**ALERT SERVICE BULLETIN**  
**Bell Helicopter** **TEXTRON**

NO. 205-04-89

**SUBJECT:** TAIL ROTOR PITCH HORN ASSEMBLY  
P/N 212-011-708-105, REPLACEMENT OF.

**HELICOPTERS AFFECTED:** Model 205A-1 helicopters with Pitch Horns 212-011-708-105 serial numbers TI-1 through TI-113 installed.

**Figure 1**  
Correct Orientation of Pitch Horn Bushing

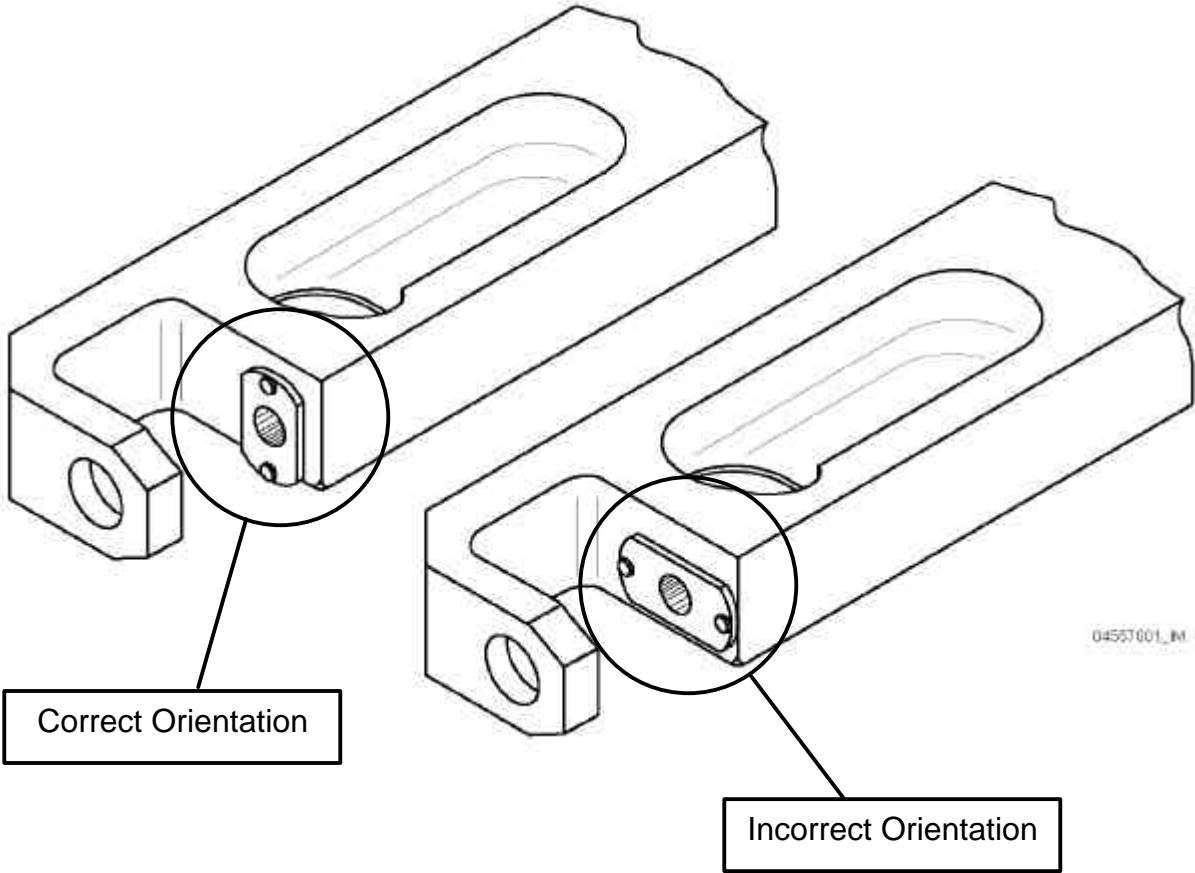
Bell Helicopter has found that subject Pitch Horns S/N TI-1 through S/N TI-113 may have incorrectly installed Bushings, which could cause the Pitch Links to contact the Bushings during Tail Rotor flapping. The resulting loads may cause excessive stress to the Pitch Horn, Pitch Link and attachment hardware between Pitch Links, Crosshead and Pitch Horn. Discrepant Pitch Horns shall be returned to Bell Helicopter, along with the mating Pitch Links and the attachment hardware. Any Pitch Horns bearing a letter "R" at the end of the affected serial number has been either reworked or found to conform, and therefore is not affected by this ASB.

1. Review historical service records and physically identify T/R pitch horn serial numbers installed on aircraft and held in spares inventory.
2. For each horn found to be within the serial number block, verify position of bushing using Figure 1. If bushing is found properly positioned, add a letter "R" at the end of the serial number, using a vibrating stylus (For example: TI-113R).

3. If bushing is found incorrectly positioned in accordance with Figure 1, remove discrepant pitch horns, mating pitch links and attaching bolts (20-057-5-14D & NAS6605H20) and return to Bell Helicopter for credit. Remove any chordwise

4. Re-assemble Tail Rotor Hub & Blade Assembly as required by replacing discrepant parts with new and/or serviceable pitch horns, pitch links and attachment hardware between pitch horn and pitch link and crosshead to pitch link. Dynamic balance as required after installation.
5. All discrepant pitch horns serial number TI-1 through TI-113 that have never seen service on an aircraft may be reworked at Bell Helicopter. Reworked pitch horns will have a letter "R" at the end of the serial number.
6. Annotate historical records to show compliance with this bulletin.
